NACELLE - EXHAUST - TRACK LINERS AND DEPLOY TUBE AND FLEXSHAFT, THRUST REVERSER ACTUATION - REPLACEMENT OF

V2500-D5

October 28, 1995

V2500-NAC-78-0107

TRACK LINER REMOVAL AND INSTALLATION FIGURE 1

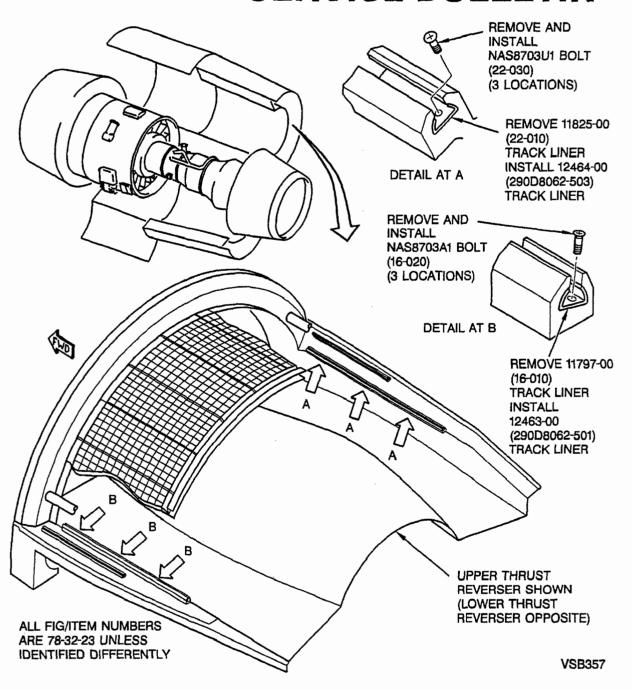
- (1) Remove and Install Upper and Lower Thrust Reverser Outboard Primary Track Liners.
 - (a) Remove three NAS8703A1 bolts from 11797-00 track liner on thrust reverser track assembly. Refer to Figure 1. Discard track liner. Keep bolts.

- (b) Put 12463-00 (Rohr P/N 290D8062-501) track liner on thrust reverser track assembly and install with three NAS8703A1 bolts. Tighten bolts to a torque of 20-25 lb-in (2,3-2,8 Nm).

- (2) Remove and Install Upper and Lower Thrust Reverser Inboard Primary Track Liners.
 - (a) Remove three NAS8703U1 bolts from 11825-00 track liner on thrust reverser track assembly. Discard track liner. Keep bolts.

- (b) Put 12464-00 (Rohr P/N 290D8062-503) track liner on thrust reverser track assembly and install with three NAS8703U1 bolts. Tighten bolts to a torque of 20-25 lb-in (2,3-2,5 Nm).

UPPER THRUST REVESER CLAMP AND CLAMP BLOCK BLOCK REMOVAL AND INSTALLATION FIGURE 2

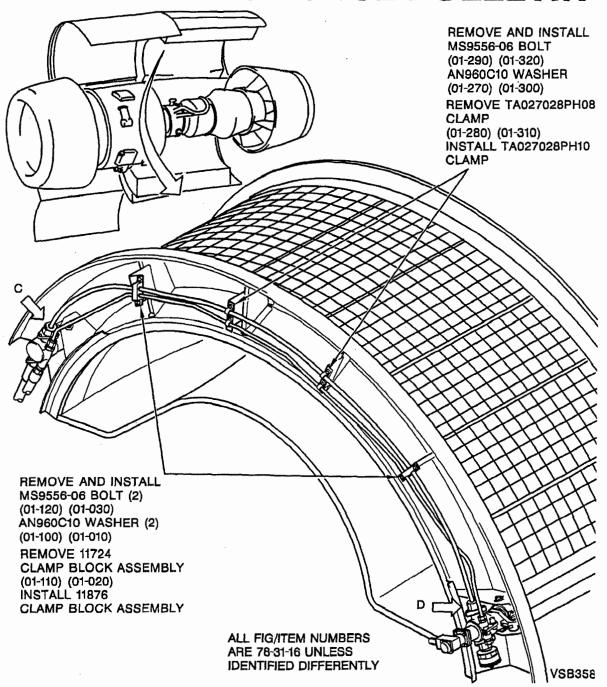
(a) Remove TY1808-01 (Rohr P/N 290D8009-6) tube assembly and TY1847-02 (Rohr P/N 290D8009-29) flexshaft from the inboard and outboard actuators. Refer to Figures 2 and 3. Refer to MD90 Aircraft Maintenance Manual, Chapter 78-31-16. Discard flexshaft, tube assembly, clamps, and clamp block assemblies. Keep bolts and washers.

(b) Put TY2084-01 (Rohr P/N 290D8009-35) flexshaft in TY2082-01 (Rohr P/N 290D8009-39) tube assembly. Install tube assembly and flexshaft on inboard and outboard actuators with eight MS9556-06 bolts, eight AN960C10 washers, two TA027028PH10 clamps, and two 11876 clamp block assemblies. Refer to MD90 Aircraft Maintenance Manual, Chapter 78-31-16. Refer to Figures 2 and 3.

UPPER THRUST REVESER TUBE AND FLEXSHAFT REMOVAL AND INSTALLATION FIGURE 3

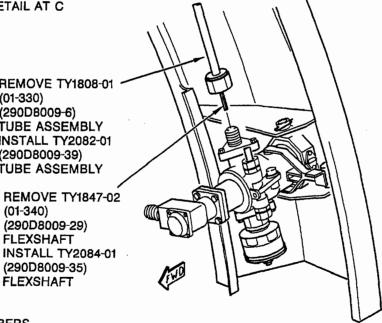
REMOVE TY1808-01 (01-330)(290D8009-6) TUBE ASSEMBLY INSTALL TY2082-01 (290D8009-39) TUBE ASSEMBLY

REMOVE TY1847-02 (01-340)(290D8009-29) **FLEXSHAFT** INSTALL TY2084-01 (290D8009-35) FLEXSHAFT

LOWER THRUST REVERSER CLAMP AND CLAMP BLOCK REMOVAL AND INSTALLATION FIGURE 4

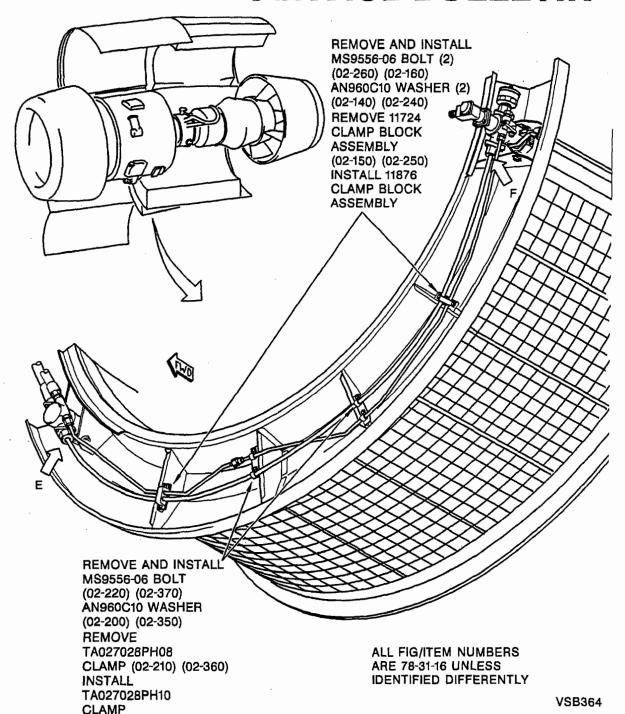
- (a) Remove TY1809-01 (Rohr P/N 290D8009-8) tube assembly and TY1848-02 (Rohr P/N 290D8009-31) flexshaft from the inboard and outboard actuators. Refer to Figures 4 and 5. Refer to MD90 Aircraft Maintenance Manual, Chapter 78-31-16. Discard the flexshaft, tube assembly, clamps and clamp block assemblies. Keep bolts and washers.

- (b) Put TY2085-01 (Rohr P/N 290D8009-37) flexshaft in TY2083-01 (Rohr P/N 290D8009-41) tube assembly. Install tube assembly and flexshaft on inboard and outboard actuators with eight MS9556-06 bolts, eight AN960C10 washers, two TA027028PH10 clamps, and two 11876 clamp block assemblies. Refer to MD90 Aircraft Maintenance Manual, Chapter 78-31-16.
- (6) Relocate the clamp/clamp block brackets.

TEE PIECE REMOVAL AND INSTALLATION FIGURE 6

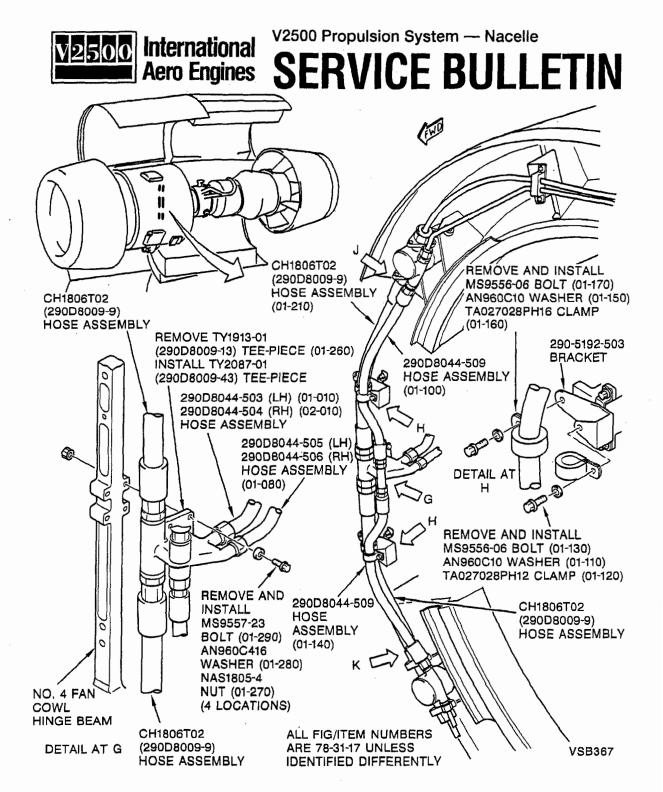
- (b) Disconnect the CH1806T02 (Rohr P/N 290D8009-9) hose assemblies at the actuators. Remove the TY1846-02 (Rohr P/N 290D8009-27) flexshaft. Refer to Figures 6 and 7.

- (i) Disconnect the CH1806T02 (Rohr P/N 290D8009-9) and 290D8044-509 hoses from the TY1913-01 (Rohr P/N 290D8009-13) tee piece. Discard the TY1913-01 tee piece.

- (j) Connect the CH1806T02 (Rohr P/N 290D8009-9) hoses to the TY2087-01 (Rohr P/N 290D8009-43) tee piece. Tighten the connectors to a torque of 440-480 lb-in (49,71-54,23 Nm).

- (1) Attach the TY2087-01 (Rohr P/N 290D8009-43) tee piece and hose assemblies to the No. 4 fan cowl hinge beam with four MS9557-23 bolts, eight AN960C416 washers, and four NAS1805-4 nuts. Tighten the nuts to a torque of 50-70 lb-in (5,65-7,91 Nm).

CROSSOVER FLEXSHAFT REMOVAL AND INSTALLATION FIGURE 7

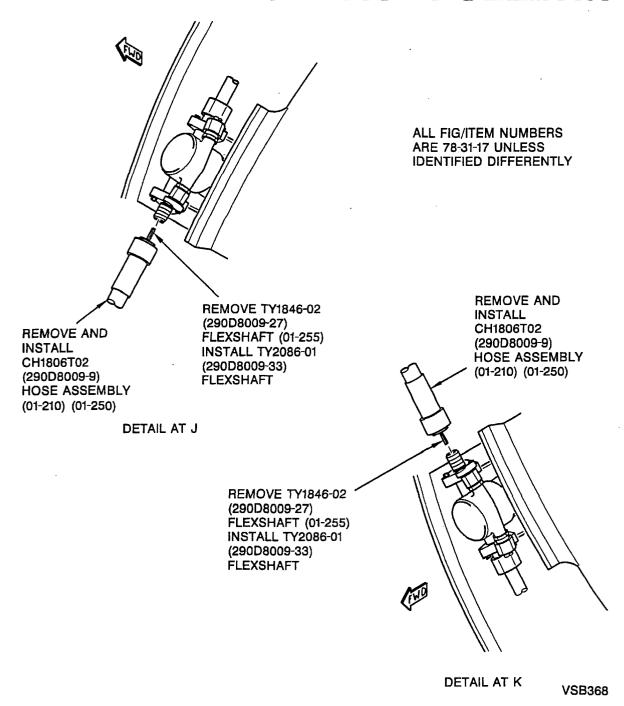
- (q) Connect the (lower) CH1806T02 (Rohr P/N 290D8009-9) hose assembly to the lower actuator, hand tight.
- (r) Install the TY2086-01 (Rohr P/N 290D8009-33) flexshaft through the (top) CH1806T02 (Rohr P/N 290D8009-9) hose assembly, the TY2087-01 (Rohr P/N 290D8009-43) tee piece, and the (lower) CH1806T02 (Rohr P/N 290D8009-9) hose assembly into the lower actuator.

- (s) Install the TY2086-01 (Rohr P/N 290D8009-33) flexshaft into the upper actuator and connect the CH1806T02 (Rohr P/N 290D8009-9) hose assembly to the actuator.
